Roland SERVICE INFORMATION

100212

G-505

COUNTERMEASURE FOR A NOISE

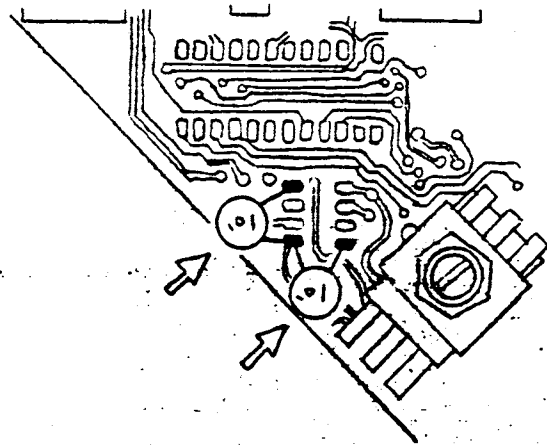
This information (modification) is effective to such a noise which will happen on GR-505 (at MODE 1/DIST. and MODE 2/DIST. & VCO) when the fingers touch "VIBRATO touch switch" on the playing.

G-505 has already been improved with the serial number 352350 and this information should be applied to G-505 guitars with the serial numbers 352349 and before.

Two ceramic condensers 0.01uF must be added on G-505 . pre-amp board as shown below.
